Reata Ranches  
186 Vinehill Dr  
Walla Walla, WA

August 15, 2024

Re: Urgent Concerns Regarding Water Filtration System at 106 N 2nd Ave, Walla Walla, WA

**Attachment 1: Actual Implementation of the filtration system**

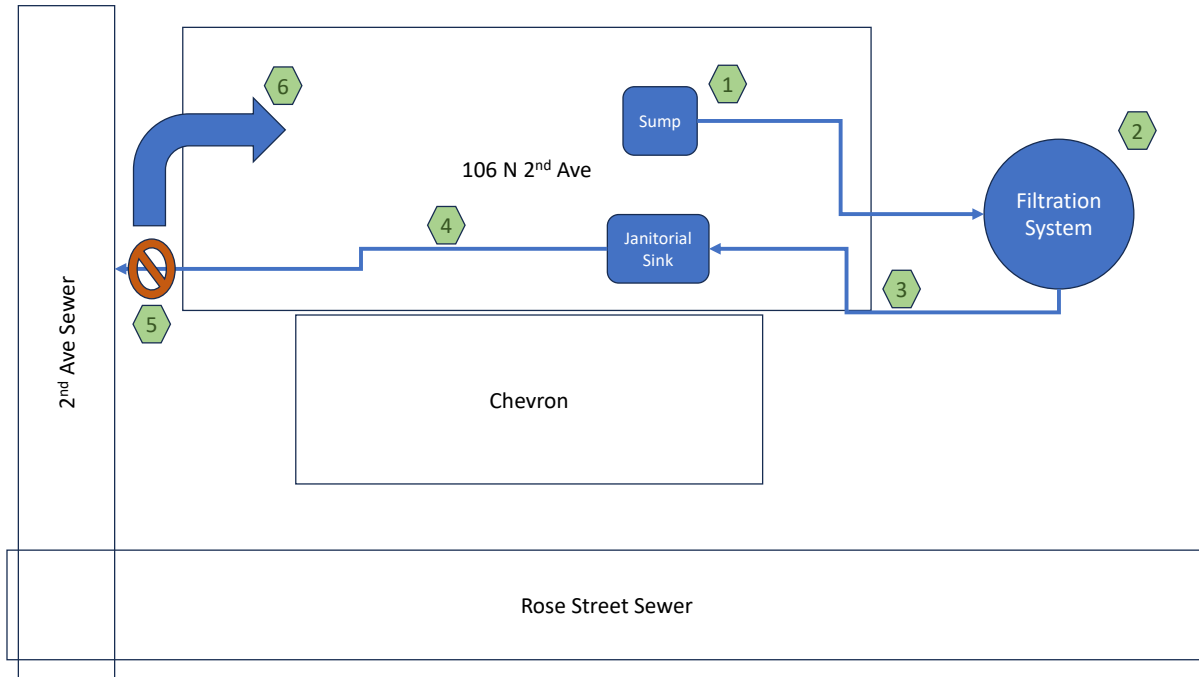
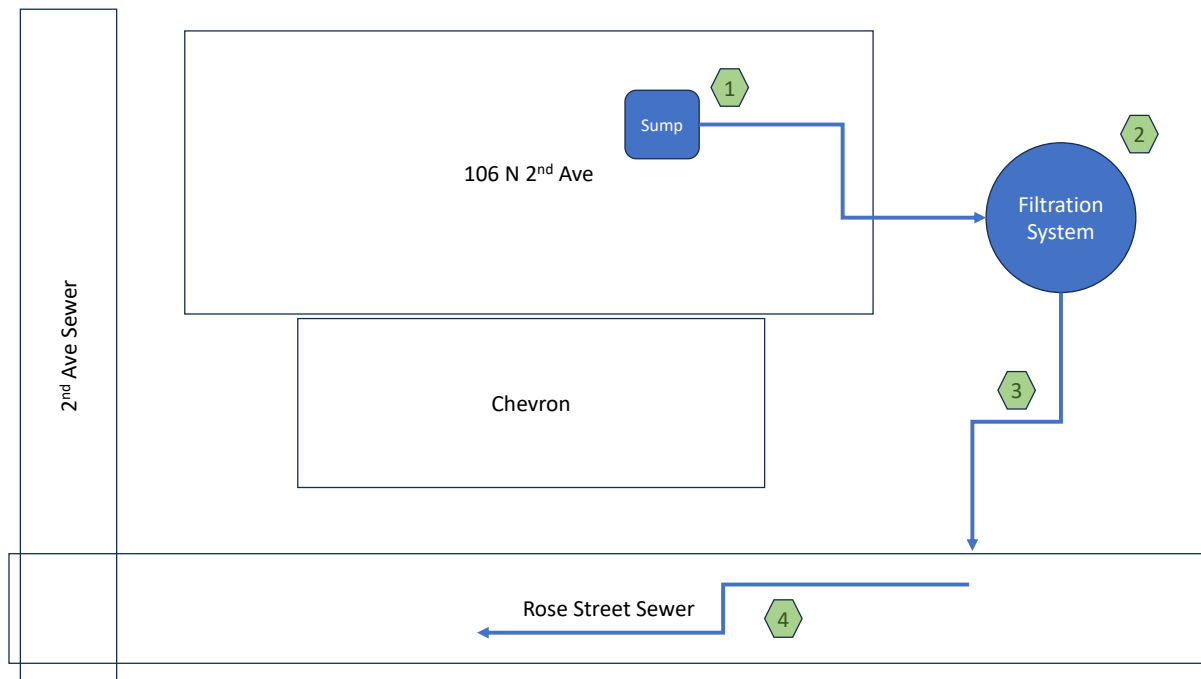
The current implementation appears to have created a closed-loop system that continuously recycles groundwater through the filtration system and back into the ground, rather than properly disposing of it via the city sewer system.

This concern stems from the actual setup (*Attachment-1*) differing markedly from the intended design (*Attachment-2*).

The intended design is for filtered water to be transported from the filtration system to the Rose Street sewer for normal sanitary water processing. Instead, the water is being sent to a janitorial sink within the building, which is not connected to the Rose Street sewer, but rather to a 2nd Ave sewer line that we have confirmed is broken. We suspect that the broken line allows the water to re-enter the ground and be reintroduced directly to the basement groundwater sumps, thus making a closed-loop system.

**Description of actual system implementation resulting in closed-loop process**

1. Ground water is pumped from basement sump to filtration system in parking lot
2. Ground water is filtered
3. Filtered water is pumped to janitorial sink
4. Janitorial sink drains outside building toward 2<sup>nd</sup> Ave Sewer
5. Filtered water is prevented from reaching 2<sup>nd</sup> Ave Sewer due to break in line between the building exterior and sewer main
6. Filtered water rejoins ground water and process begins again at Step 1

1. Immediately validate that filtered water is being properly transported to a Walla Walla sewer line.
2. Redesign and reimplement the system promptly if the current setup is confirmed to be ineffective.

**Attachment 2: Intended design of the filtration system**

1. Ground water is pumped from basement sump to filtration system in parking lot
2. Ground water is filtered
3. Filtered water is pumped to Rose Street Sewer
4. Filtered water joins common city sewage for processing in city sewage treatment facility
